**Nomad**

SERVICE BULLETIN

SUBJECT: REDESIGNED OIL STOP COCK (MOD N376) - IMPROVED OIL STOP COCK
(OPTION G240 AND G240-24) FOR FITMENT OF ENGINE NACELLE LOWER
FRONT FAIRING (POST MOD N374)

Figure 1

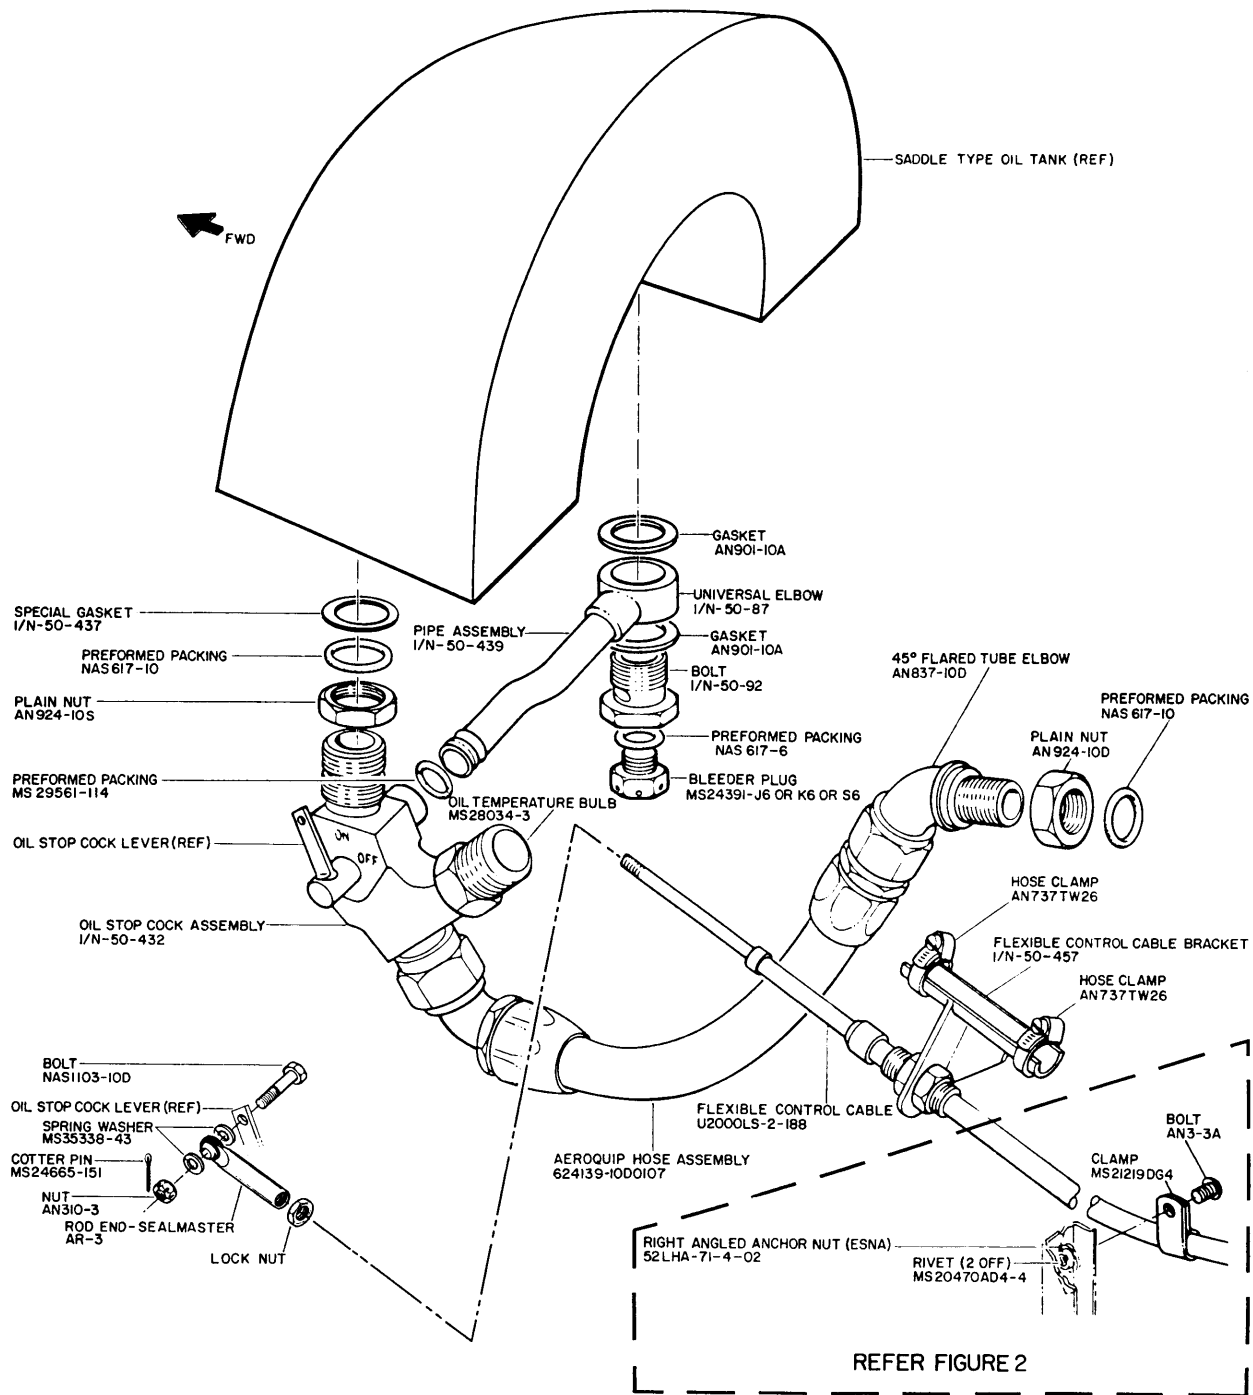
The redesigned stop cock inlet connection screws into the LH outlet port (viewed looking forward) of the saddle type oil tank. A modified balance pipe connects a universal elbow at the RH tank outlet to the inlet port of the cock. A bleeder plug, to facilitate draining the tank is also fitted to the RH tank outlet. The oil temperature bulb previously fitted at the RH tank outlet is now fitted to the redesigned stop cock.

- (23) Set the associated oil stop cock shut-off control lever on the overhead console to OFF and connect the flexible control cable rod end to the stop cock as shown in Figure 1. Ensure that the threaded end of the control cable is in safety, for example, threaded end of the control cable visible through the safety hole in the rod end or at least .3 inches engagement of threaded end of the control cable if no safety hole is provided in the rod end.

Installation of Oil Stop Cock Control Cable Clamp - Scrap View
 Figure 2

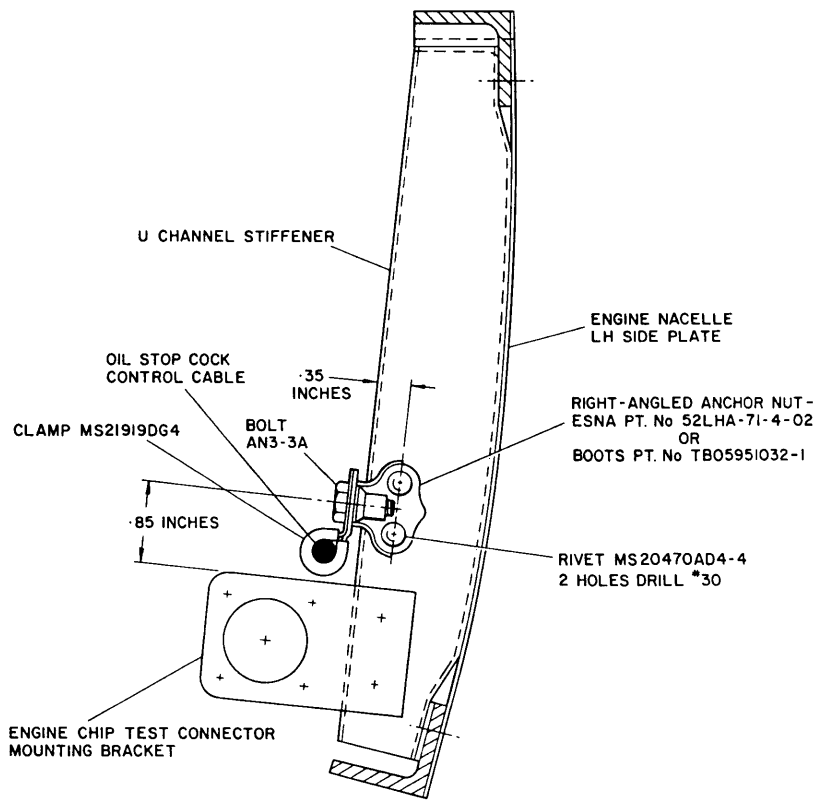
- (25) Clamp the flexible control cable to the LH side of the nacelle as shown in Figure 2, using clamp (Ref step 6) and bolt (Ref Option G240 or G240-24 IPC Supplement, Figure 1, Sheet 2, item 65). The bolt screws into a right-angled anchor nut P/N ESNA 52LHA-71-4-02 (alt BOOTS TB05951032-1) which is attached by two rivets P/N MS20470AD4-4 to the nacelle structure.

Engine Front Elevation
Figure 3

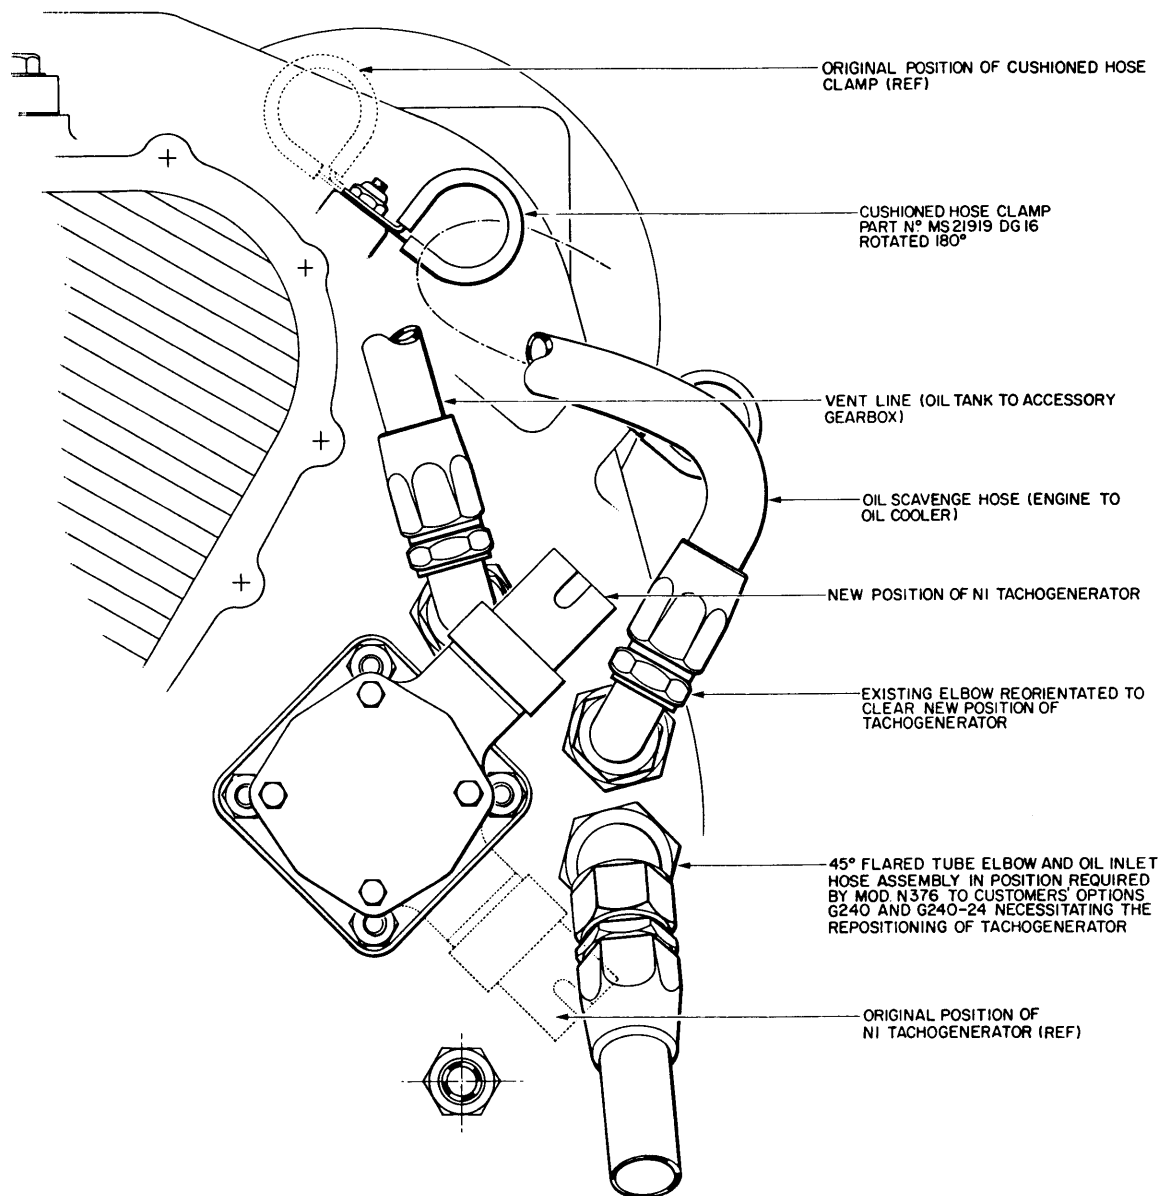
- (18) Reposition the N1 tachogenerator and reorientate the oil scavenge hose (engine accessories gearbox to oil cooler) to the positions shown in Figure 3. When refitting the tachogenerator in its new position discard the existing gasket and fit a new gasket (Ref IPC 79-10-01 Figure item 6). Torque tighten the tachogenerator attaching nuts to between 50 and 70 lb in.

- NOTE: The repositioning of the N1 tachogenerator is necessary to provide clearance for the fitting of the oil inlet hose assembly and 45° flared tube elbow to the engine accessories gearbox. The reorientation of the oil scavenge hose becomes necessary to provide clearance between the hose and the N1 tachogenerator in its new position.
